**HISTORIC PRESERVATION COMMISSION
JANUARY 27, 2022
ASSEMBLY HALL**

**PINEHURST, NORTH CAROLINA
4:00 PM**

- I. Call to Order
- II. Approval of Minutes
 - A. 12-16-2021 Special Meeting Minutes
 - B. 12-16-2021 Regular Meeting Minutes
- III. Public Hearing
 - A. COA-2021-00214 (5 CHINQUAPIN ROAD)

Site plan

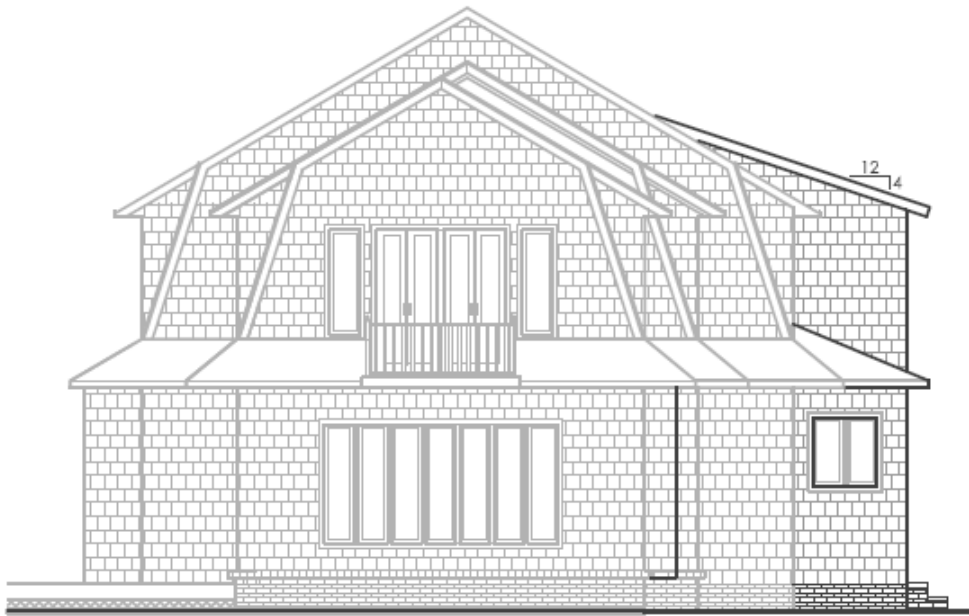
The applicant requests a Certificate of Appropriateness for exterior modifications at 90 Linden Road. Modifications include a rear kitchen addition, addition of ventless fireplace, outdoor fireplace structure at pool house and detached garage addition The property is further identified as Moore County PID Number 00014733. The home was originally built in 1940. Previous COA’s have been issued for a two-story addition to the home and exterior windows to the pool house. This request includes a rear kitchen addition to the rear of the home totaling about 150 square feet with all materials to match the existing. A small ventless fireplace is proposed on the rear elevation of the downstairs portion of the recently approved addition. An outdoor fireplace/chimney structure is proposed at the pool house located in the front yard. A 695 square foot addition with a 410 square foot second floor apartment to the existing detached garage to the rear and left of the lot is proposed with this request as well.

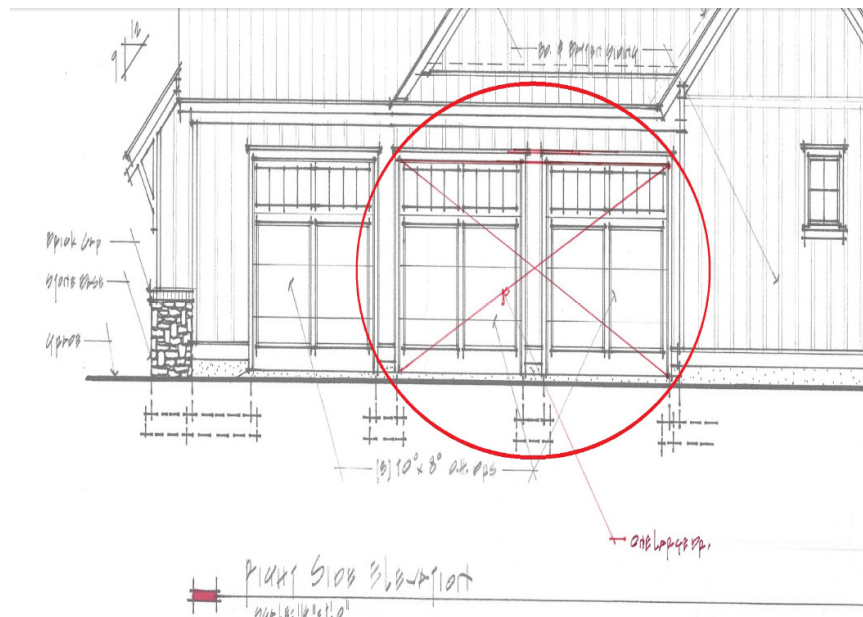
The applicant requests a Certificate of Appropriateness for exterior modifications to the property located at 125 Kelly Road. The proposed modifications include changing of garage doors from two single doors to one double door, screened porch at the front of the dwelling, and screened porch at the rear of the dwelling. The property is further identified as Moore County PID Number 00014377. The original home which was built in 1950 was approved for demolition by the Commission and subsequently the new construction in April of 2021. This request is for modifications to the previously issued COA for the new construction.

A Minor Work COA was recently issued to change the exterior color from the approved gray to white. The design of the garage door from what was previously approved is not proposed to change, just the overall dimension from three single bays to one single bay and one double bay door. The porch area proposed to be screened in are on the rear elevation not visible from the street and a front elevation porch area interior to the courtyard.

Per the adopted Historic District Standards, eliminating or adding doors is considered Major Work. Screening in existing side and rear porches not visible from the street are considered Minor Work. Thus, the garage door change and front screened porch are Major Work items requiring review by the Historic Preservation Commission for issuance of a Certificate of Appropriateness.

Proposed change from two single bay doors to one double bay door

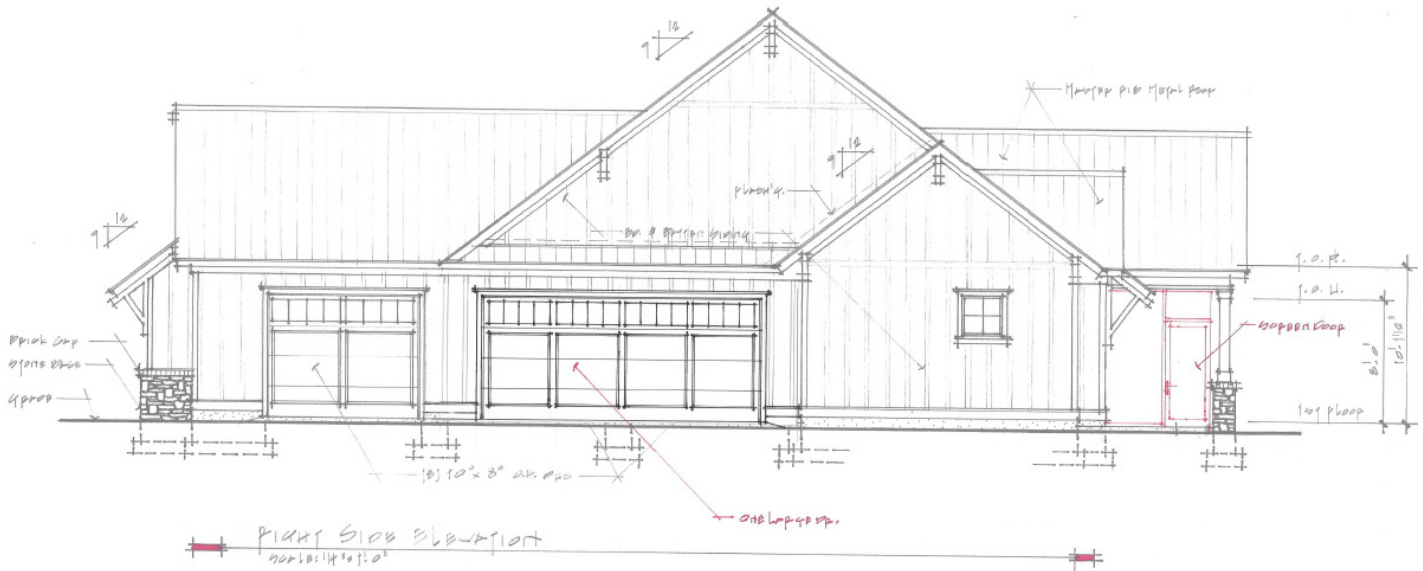
The applicant has submitted a complete application and provided additional documentation in an attempt to satisfy the burden of proof. The request to change two single garage doors into one double door is not inconsistent with the standards (compatible with the architectural character) as the design, style, materials and color will not change just the overall dimension. Additionally, it is not a prominent feature of the front façade as it's located on the right side elevation. Double garage doors with an additional single door is present in the district. The screening in of the rear porch meets the standards and can be approved as Minor Work. The proposed screening in of the front porch area would need to be determined by the Commission to be both compatible with the architectural character of the structure and congruous with the district per the adopted standards.

Location of existing building to be demolished

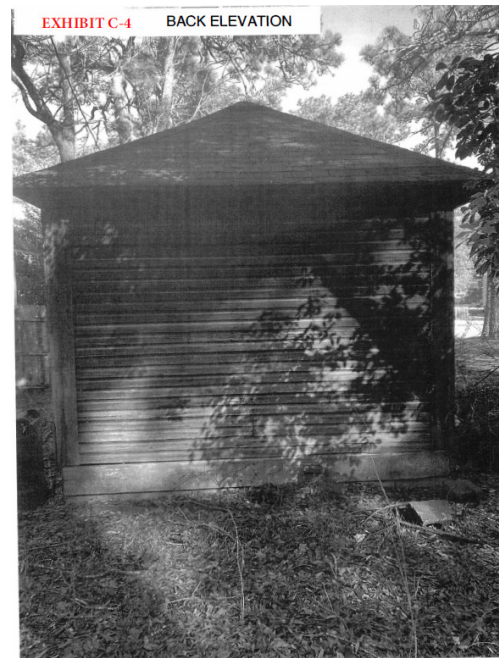
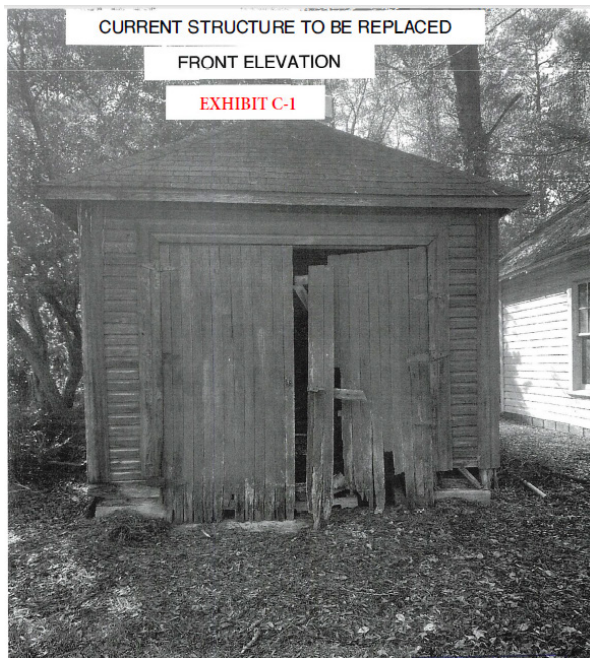
1. Adjacent property owners have been noticed and the property was posted.
2. The applicant has submitted an application, elevation sketch, and sketch plan.
3. The applicant proposes to demolish the existing accessory (storage) building and construct a new detached garage in the rear yard.
